Access Compliance Report

Public Rights-of-Way

(Curb Ramps)

Intersection ID: 43869	Main Street: CALDWELL_RIDGE_PY	Cross Street: SIDNEY_CREST_AV	Location: SW
ADA ID: A808A37BB686	Ramp Type: Perp	Initial Pass/Fail: Fail	Overall Compliance: No
Severity Score: 10			
Codes/Mitigation Info/Possible Solution		Field Measurements/Component Compliance

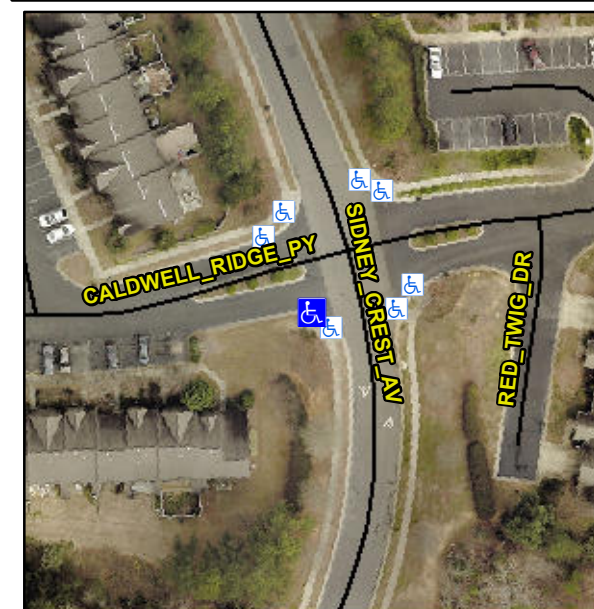
Not Found, R304.5.1, R304.5.3

Compliance	Description	Data	Compliance	Description	Data
N/A	Ramp Length (in)	50.0	Yes	Ramp Slope (%)	5.7
No	Ramp Width (in)	39.5	No	Ramp XSlope (%)	3.9
N/A	Flare Type LT	N/A	N/A	Flare Type RT	N/A
N/A	Flare Slope LT (%)	N/A	N/A	Flare Slope RT (%)	N/A
N/A	Flare Traversable LT?	N/A	N/A	Flare Traversable RT?	N/A
N/A	Landing Length (in)	N/A	N/A	DWS Provided?	N/A
N/A	Landing Width (in)	N/A	N/A	DWS Contrast?	N/A
N/A	Landing Slope (%)	N/A	N/A	DWS Length (in)	N/A
N/A	Landing X Slope (%)	N/A	N/A	DWS Full Width?	N/A
N/A	Landing Curb? (Y/N)	N/A	N/A	DWS Offset (in)	N/A
N/A	Shared Landing?	N/A			
N/A	Gutter Ponding?	N/A	N/A	Gutter Slope (%)	N/A
N/A	Gutter Lip Ht (in)	N/A	N/A	Gutter X Slope (%)	N/A
N/A	Painted X Walk1?	No	N/A	Painted X Walk2?	N/A
	X Walk 1 Direction	To N		X Walk 2 Direction	N/A
N/A	X Walk 1 Width (in)	N/A	N/A	X Walk 2 Width (in)	N/A
	X Walk 1 Slope (%)	0.9		X Walk 2 Slope (%)	N/A
	X Walk 1 X Slope (%)	3.6		X Walk 2 X Slope (%)	N/A

Remove & Replace Entire Ramp.
